The Santa Clara Valley Transportation Authority (VTA) has prepared this Supplemental Environmental Impact Report (SEIR) in accordance with the California Environmental Quality Act (CEQA), Public Resources Code 21000 et seq.; and the CEQA Guidelines, California Administrative Code, 15000 et seq. Per CEQA Guidelines Section 15163(2)(b), a supplement to an EIR “need contain only the information necessary to make the previous EIR adequate for the project as revised.”

The SEIR updates information presented in the *Silicon Valley Rapid Transit Corridor-BART Extension to Milpitas, San Jose and Santa Clara - Final Environmental Impact Report* (November 2004). The VTA Board of Directors certified the Final Environmental Impact Report (FEIR) in December 2004 in accordance

DESIGN CHANGES

Figure 1.3-4: Design Changes in San Jose

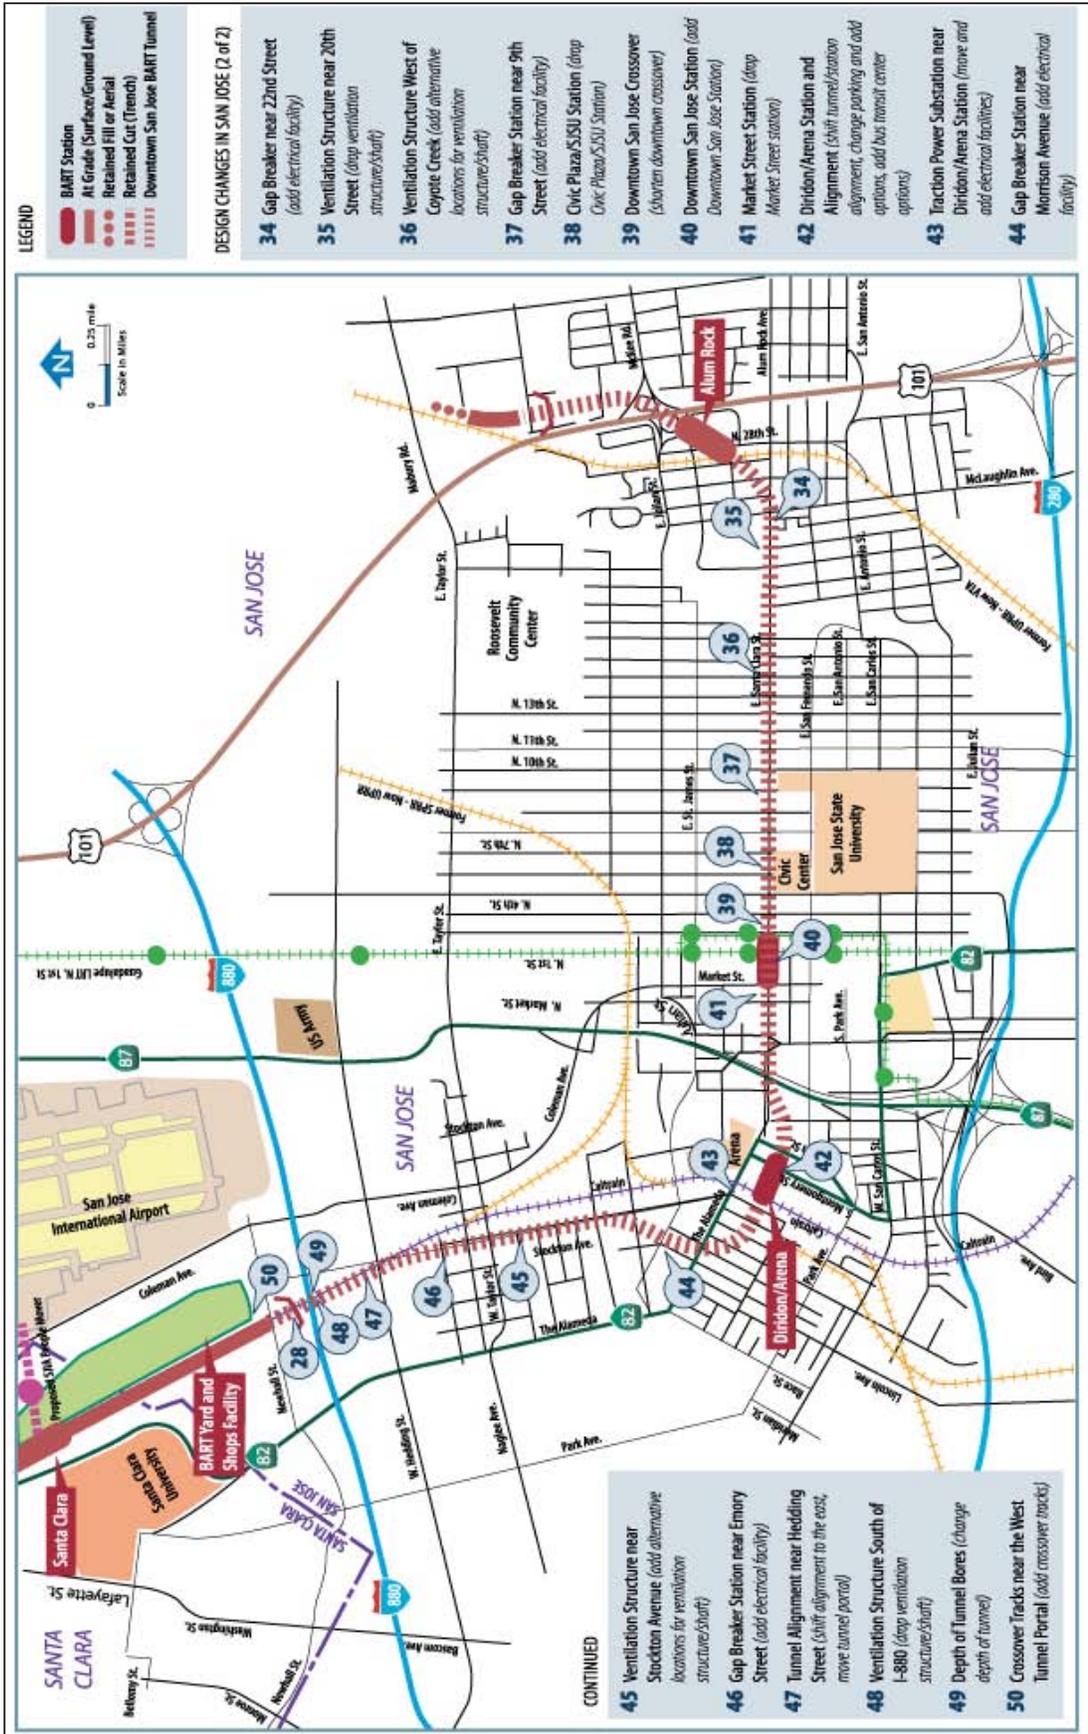
Design Change 21. Communication Facilities south of Hostetter Road.

- ❑ In the FEIR, a train control building is not identified south of Hostetter Road.
- ❑ In the SEIR, a train control building would be located south of Hostetter Road and east of the railroad ROW.

Design Change 22. Electrical and Communication Facilities near Berryessa Road.

- ❑ In the FEIR, a traction power substation would be located west of the railroad ROW and either south of Aschauer Court or north of Berryessa Road.
- ❑ In the SEIR, this substation would be located south of Berryessa Road under the BART aerial structure at the north end of the Berryessa Station area. The site would also include a train control room.

Design Change 23. Berryessa Station.

- ❑ In the FEIR, there are two options for the parking structure. One option includes a three- to six-level parking structure on 5.1 acres in the northeast section of the station area. A second option includes a three- to six-level parking structure on 6.2 acres in the southwest section of the station area. Access to the station area from the north would be from Berryessa Road via a new street along the west side of the railroad ROW. Right-of-way required for this access road would displace up to 400 vendor stalls at the San Jose Flea Market.

- ❑ In the SEIR, the northeast parking structure is eliminated, and there are two new options for parking. Under the Parking Structure with Surface Parking Option, a four- to six-level parking structure on 3.4 acres would be constructed in the same general location as the parking structure in the southwest section of the station area described in the FEIR. Property would be acquired to the east of the railroad ROW and north of Mabury Road. This area would be designated for surface parking and/or future transit facilities. Access to this eastern parking area would be from a new access road off Mabury Road. A new traffic signal would be installed at the intersection of this new road and Mabury Road. Additional surface parking

and/or future transit facilities would be located as needed within the station area. Under the Surface Parking Option, the area designated for the parking structure under the Parking Structure with Surface Parking Option would be designated for surface parking only and/or future transit facilities. Additional surface parking and access would be provided as described under the Parking Structure with Surface Parking Option. Under either option, access to the station area from the north would be from Berryessa Road via a new street along the east side of the railroad ROW.

Design Change 24. Crossover Tracks and Pocket Track near Berryessa and Mabury Roads.

- ❑ In the FEIR, three crossover tracks would be located on the aerial structure from south of Berryessa Station to south of Mabury Road. A pocket track would be located between the three crossover tracks.
- ❑ In the SEIR, the crossover tracks located south of Mabury Road are eliminated. Two crossover tracks and a pocket track would be located on the aerial structure from south of Berryessa Station to Mabury Road.

Design Change 25. Electrical and Communication Facilities near Mabury Road.

- ❑ In the FEIR, a high voltage substation, switching station, gap breaker station, and train control building would be located north of Mabury Road and east of the railroad ROW. Approximately 1,400 feet of new high-voltage line would run from the substation along the north side of Mabury Road and connect to an existing Pacific Gas & Electric (PG&E) high-voltage line near the intersection of Mabury and King roads.

- ❑ In the SEIR, this location north of Mabury Road and east of the railroad ROW is eliminated. Instead, these facilities would be located south of Mabury Road and west of the railroad ROW. An access easement/road would connect the site to DOT Way, a private street that leads to the City of San Jose Mabury Yard. There are two options for a high-voltage line connection from the high voltage substation to the PG&E Mabury Substation, which located south of the King Road/Las Plumas Avenue intersection. Under the Mabury Underground Option, the

new line would run underground within the ROW of Mabury Road beginning at the high voltage substation and extending to King Road. An existing PG&E high-voltage line on King Road would be upgraded, extending for approximately 2,500 feet from Mabury Road to the PG&E Mabury Substation. Under the Las Plumas Overhead Option, the new line would begin at the high voltage substation, run south along the BART alignment, continue along Marburg Way, then along Las Plumas Avenue to King Road. The existing PG&E high-voltage line on King Road would be upgraded, extending for approximately 550 feet to the PG&E Mabury Substation.

Figure 1.3-5: Design Changes in Santa Clara

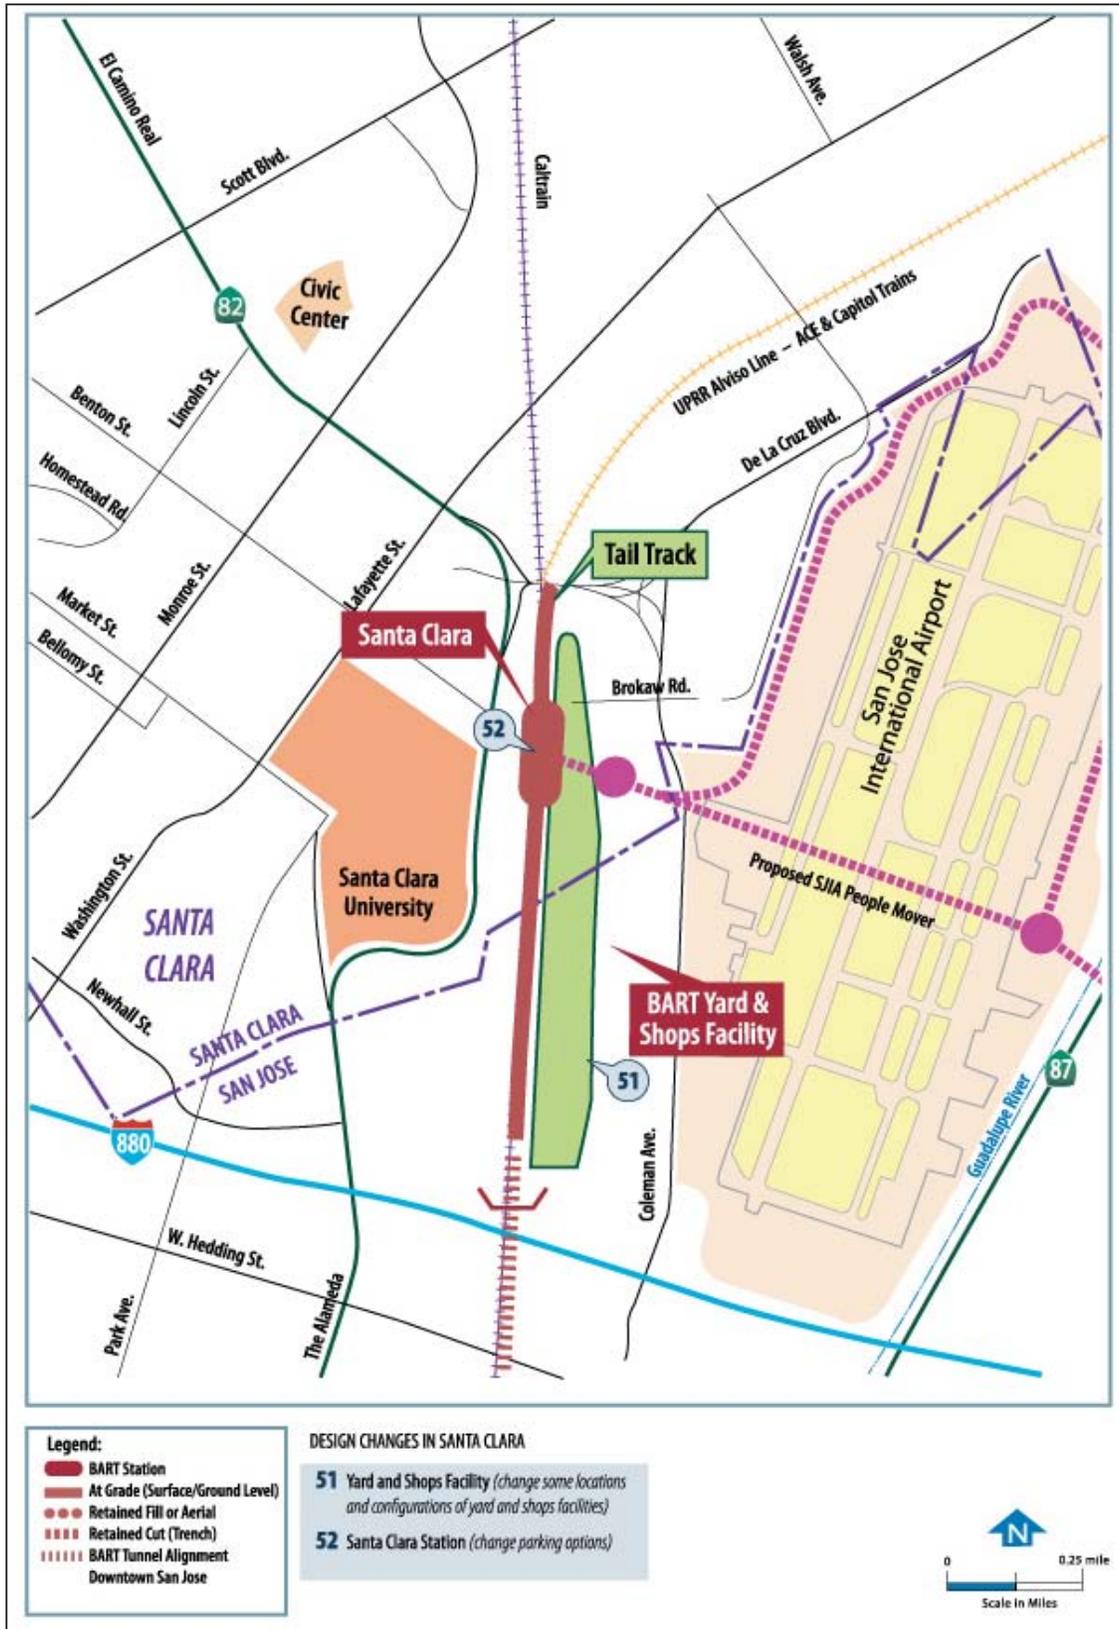
Design changes in Santa Clara include the re-configuration of Project features at the yard and shops facility and the Santa Clara Station. The yard and shops facility, which is partially located in San Jose but mostly located in Santa Clara, is discussed entirely in this section. The railroad intrusion detection system described for Fremont would also be installed in Santa Clara (see Design Change 7). The design changes are listed in Table 1.3-4 and shown in Figure 1.3-5. A full description of each design change in Santa Clara is provided in Section 3.2.4.

Design Change 51. Yard and Shops Facility.

- In the SEIR, the yard and shops facility does not include any property, buildings, or other facilities south of I-880. Instead, the yards and shops facility in San Jose would be located north of Newhall Street. Other noteworthy changes to the yards and shops facility in the

city include the identification of additional property acquisition on the FMC property (approximately 0.41 acres); the reconfiguration of the size and location of some of the buildings and facilities; the elimination of the radio tower located midway between Brokaw Road and Newhall Street; the elimination of a BART Transit Police Station (now located at the Alum Rock Station); the addition of a retention pond; and the addition of parking spaces for employees, authorized visitors, and delivery and service vehicles.

Design Change 52. Santa Clara Station.

- ❑ In the FEIR, there are two options for the parking structure. One option includes a three- to five-level parking structure on 3.6 acres north of Brokaw Road. A second option includes a three- to five-level parking structure on 4.0 acres south of Brokaw Road.²
- ❑ In the SEIR, the south parking structure is eliminated. The Santa Clara Station would include a three- to four-level parking structure on 3.3 acres located north of Brokaw Road in the same general area as described in the FEIR. If the No Parking Structure Option were chosen for the Diridon/Arena Station (see Design Change 42), the Santa Clara Station would include a five- to six-level parking structure in the same location. Additional surface parking and/or future transit facilities would be located as needed within the Santa Clara Station area near Coleman Avenue.
